European Aviation Safety Agency

Comment-Response Document 2017-04

Appendix to ED Decision 2017/021/R

RELATED NPA 2017-04 — RMT.0591) — 8.12.2017

CS ADR-DSN.D.245 Width of taxiways

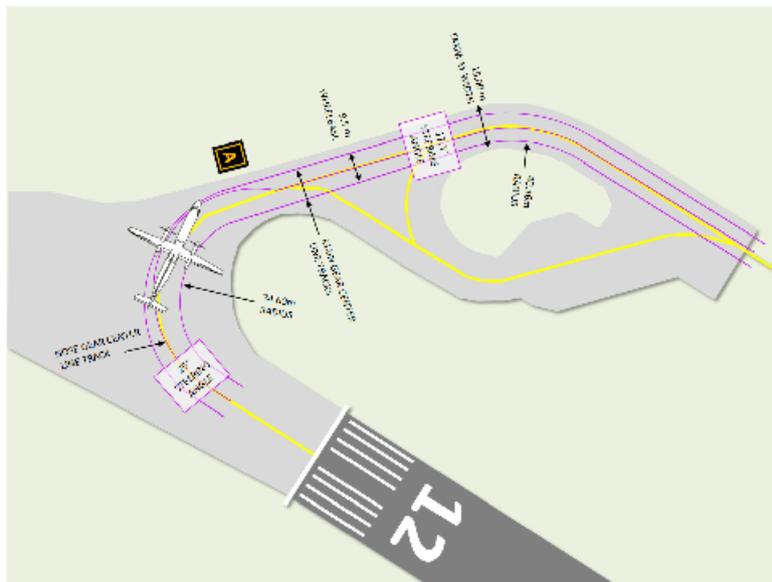
This CS stipulates that taxiway width for aircraft with OMGWS 9m up to but not including 15m shall be 23m.

For the DHC-8-400 this is very restrictive. The DHC-8-400 OMGWS is 9.52m (while the distance between the main wheel axes is 8.8m). This means that minimum allowed taxiway width is 23m.

Widerøe has routinely operated the DHC-8-400 on 15m taxiways, which is unproblematic as shown on the below illustration.
